North Sydney Wharf Upgrade

Submissions report

Transport for NSW | February 2021

Figure 1-1: Plan of the proposal

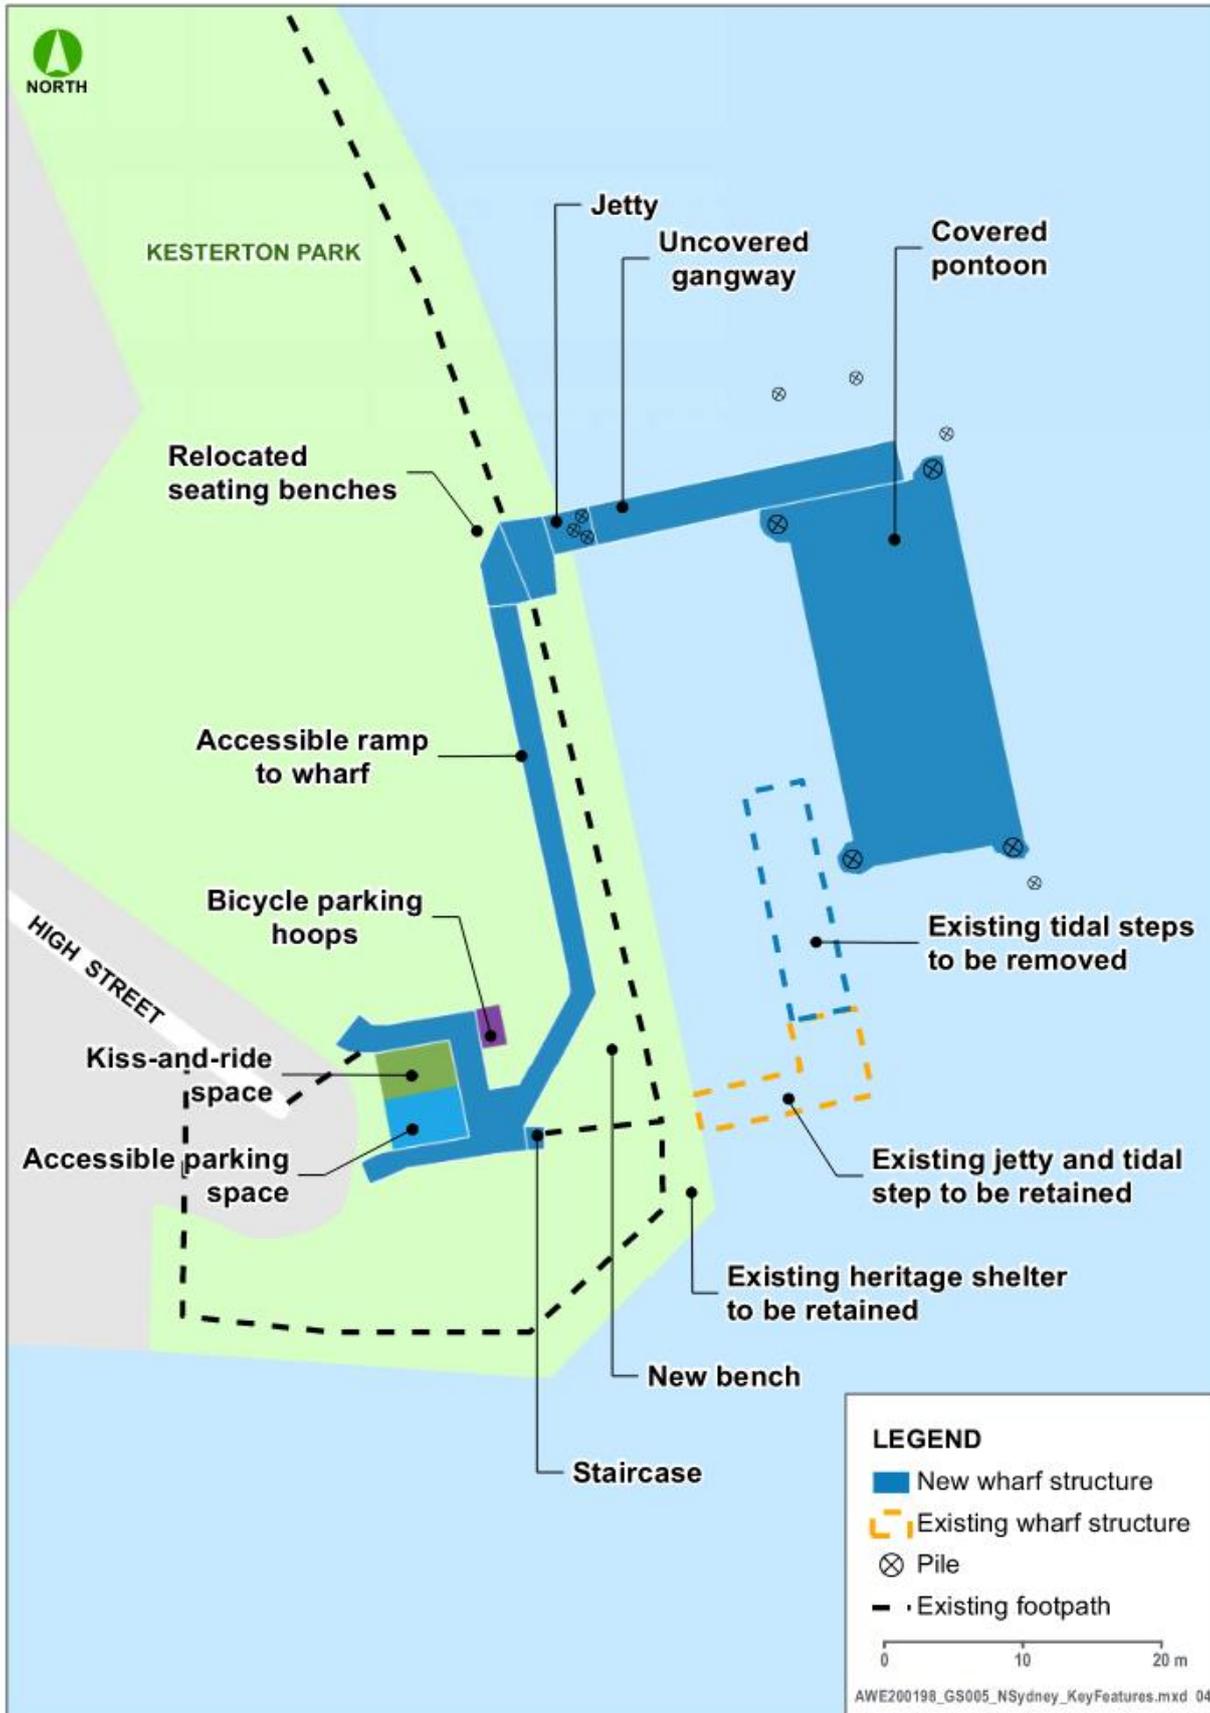
- Proposed an alternate design that locates the pontoon to the north of the proposed gangway. The intent of the suggested design change is to provide navigational access to the existing wharf and the western side of the new wharf
- Questioned the location of the new wharf and whether it can be in place of the existing wharf stairs
- Asked whether the entrance to the new wharf could be moved closer to the existing wharf entry
- Suggested the existing pathway that joins the children's playground and High Street be upgraded to provide access from High Street to the new wharf
- Suggested that the old pontoon should be demolished and new pontoon re-positioned.

Respondents raised concerns over the proposed uncovered gangway, whether there was adequate protection from wind and rain on the new wharf and questioned whether the opal card readers would be undercover.

North Sydney Council has expressed overall opposition to the proposal design, and expressed concern over the loss of open space in Kesterton Park in order to provide for the Kiss and Ride space and accessible parking space. North Sydney Council requests a review of the design of the accessible ramp and other structures be undertaken with a view to minimising the impact on Kesterton Park including no loss of parkland, no net increase of hard surfaces within the park and no removal of mature trees.

The proposed configuration of the new wharf was selected based on a number of factors including to; minimise movement of the pontoon due to the wind and wave movement, thereby maximizing customer comfort and safety, increase the clearance in navigational channel (to allow for safe passage of water

Further, the position of the new wharf was chosen to accommodate the new landside accessible direct ramp between High Street and the new wharf. The new ramp would provide access for people with assisted mobility and would comply with relevant legislation. To achieve the required slope, and to allow customers to travel safely up and down the ramp, the ramp would need to be 30 metres long, starting from the footpath at the end of High Street, connecting to the top of the gangway. The proposed alignment of the ramp minimises the impact on the Kesterton Park and requires the gangway to be located further north away from High Street. Locating the gangway closer to High Street would require a switchback ramp that would have a greater impact on the park.

The project team has considered this feedback, and with the exception of the berthing face, the glazing on the wharf has been increased in the design to provide additional weather protection on the pontoon.

As part of the detailed design phase the project team will look at opportunities to re-position the path to minimise the impact on the park and trees, reduce the concrete hardstand and remove redundant concrete while achieving DDA compliance between High Street and the new wharf. Transport for NSW will do this in consultation with North Sydney Council.
